ADDENDUM NO. 1

Issue Date:	October 9, 2026
School / Facility Name:	Indian River Elementary
Project Name:	Replace Switchgear Bldg. 4
Owner's Project No.:	2648222

INDIAN RIVER ELEMENTARY

REPLACE SWITCHGEAR BLDG. 4
VCS Project NO. 2648222
650 ROBERTS ROAD
EDGEWATER, FL 32141

DRAWING NO.
E501

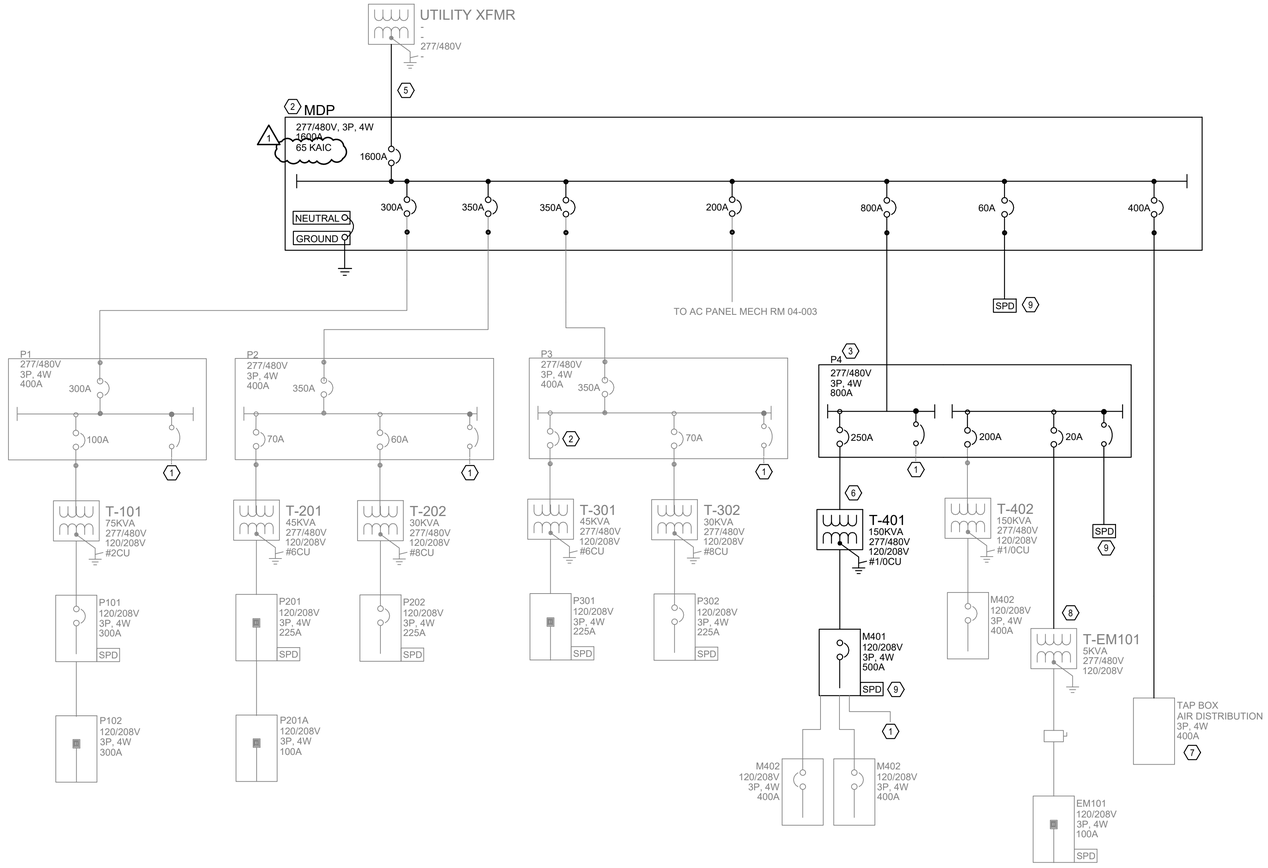
4. Question: Sheet E501 shows the new MDP as 42 kAIC. The MDP schedule on Sheet E701 shows 65 kAIC. Please confirm the required AIC rating for the new MDP.

5. Question: Sheet E501 shows a 250A breaker feeding T401 and a 200A breaker feeding T402. The P4.S2 schedule on Sheet E701 shows 225A breakers for both T401 and T402. Please confirm the required breaker sizes.

Answer: 65 KAIC is correct. See revised drawing E-501 Attached.

Answer: T401 is to be a 250A C/B and feeder as shown on the one-line diagram. T402 should be 200A as shown on the one-line diagram. See revised drawing E-701 Attached.
